**City of Poughkeepsie
Planning Board
Meeting Agenda**

2. 36 NORTH CLOVER STREET, PELTON MANOR - SITE PLAN

Application for Site Plan Amendment review regarding establishment of 46 residential units and related parking and amenities. Owner/Applicant: Pelton Partners, LLC; Consultant: LRC Group; Grid #6062-75-837228; Zoning District: R-4 (Medium-High Density Residential); File #PB2023-044

TT-1

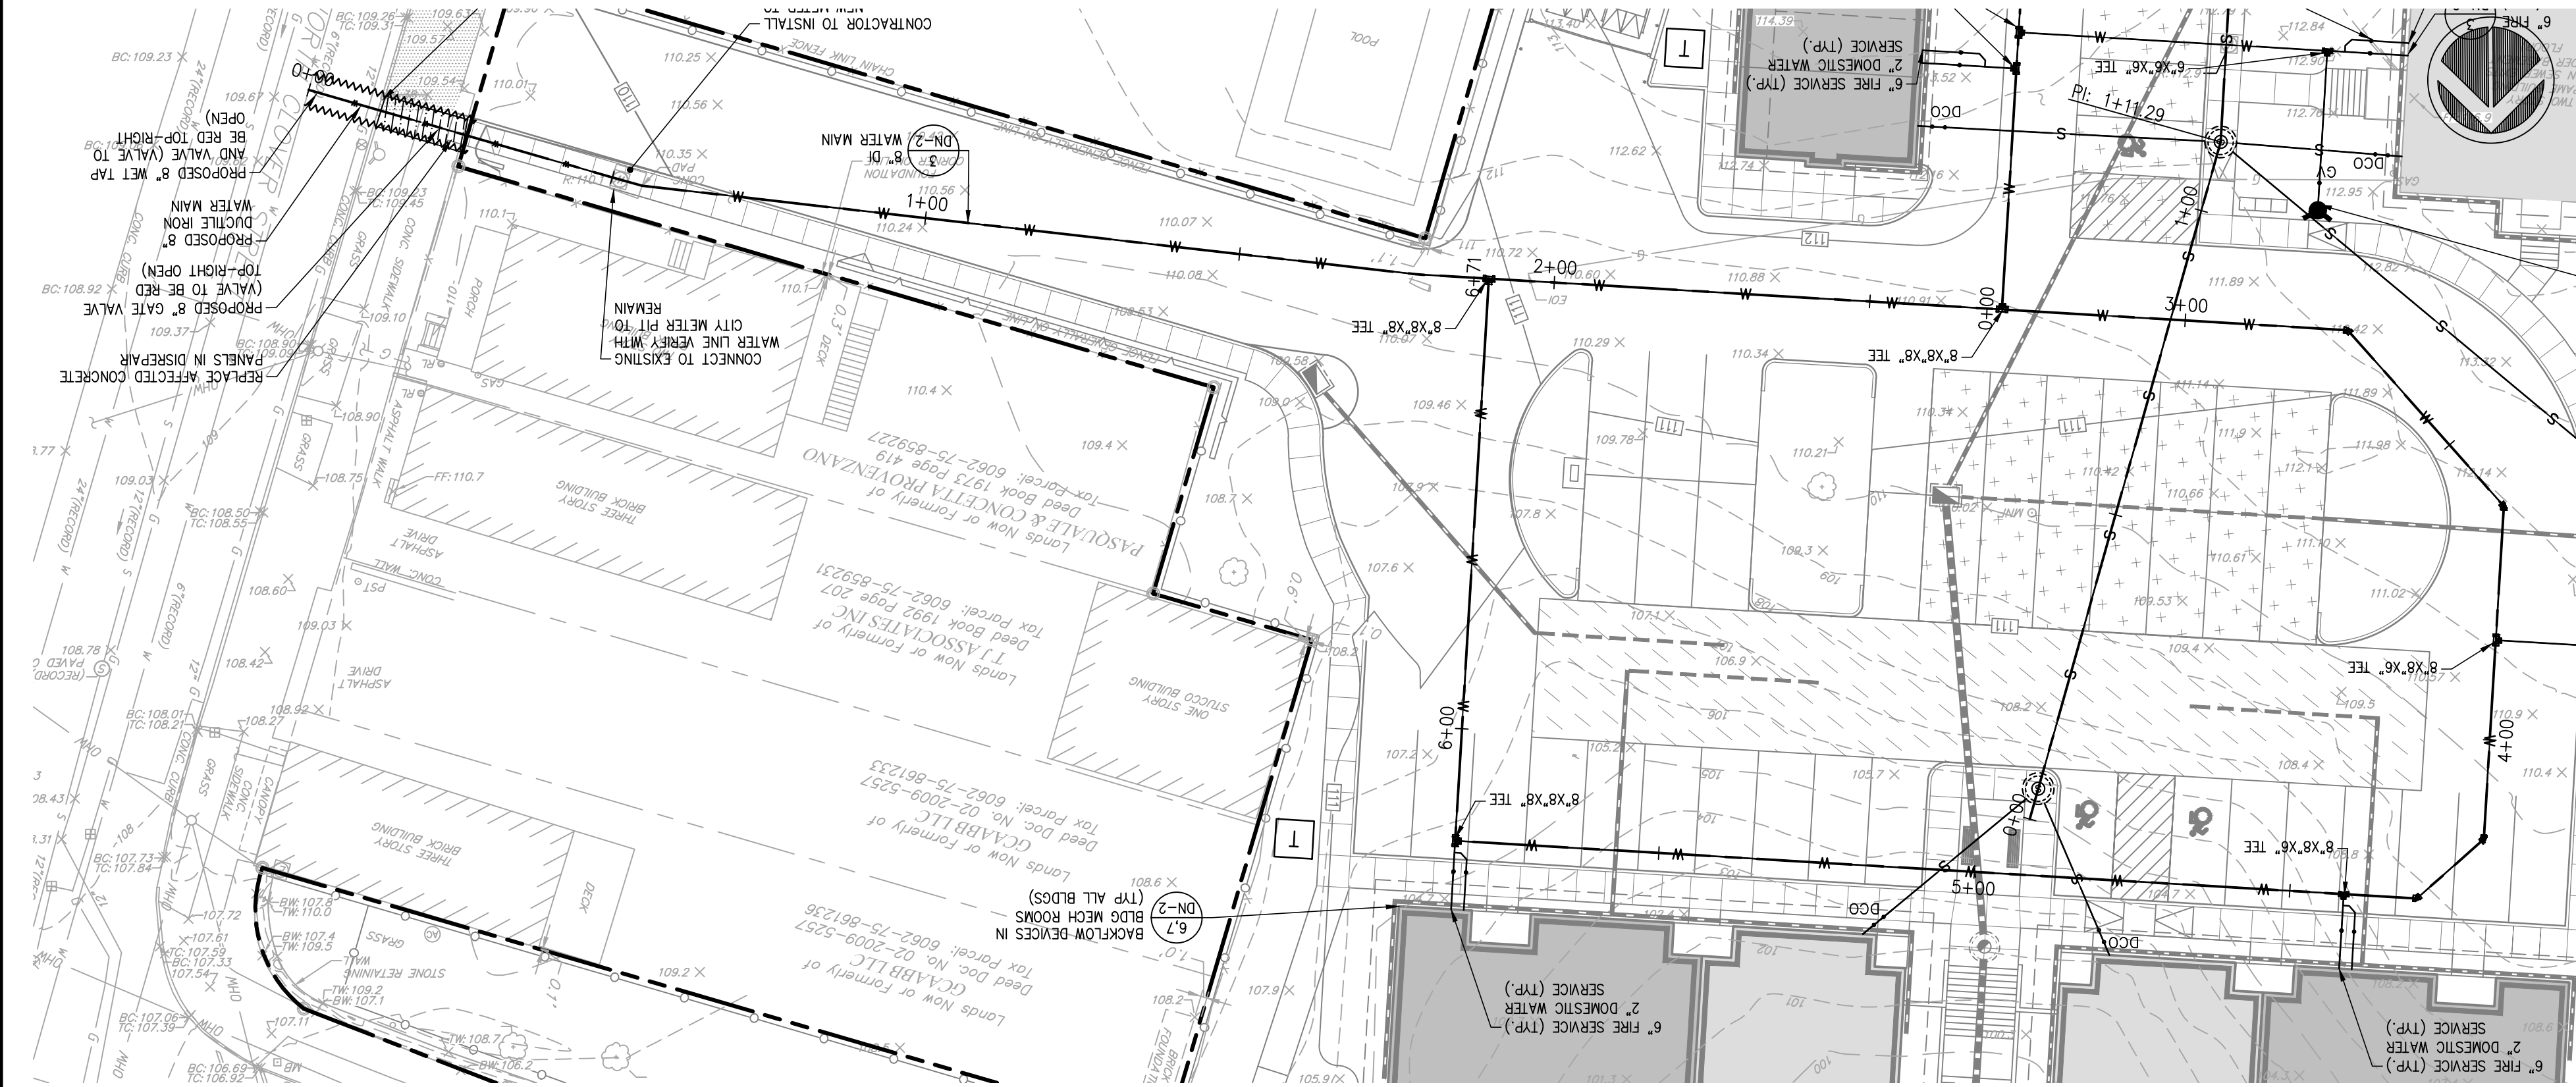
1. Drawing TT-1 Should reference the template they used for turning radius. It should state Poughkeepsie Tower Ladder 2 turning specs.
2. At the time of final drawings. A complete fire sprinkler drawing and calculations should show sufficient water supply to meet system demand.
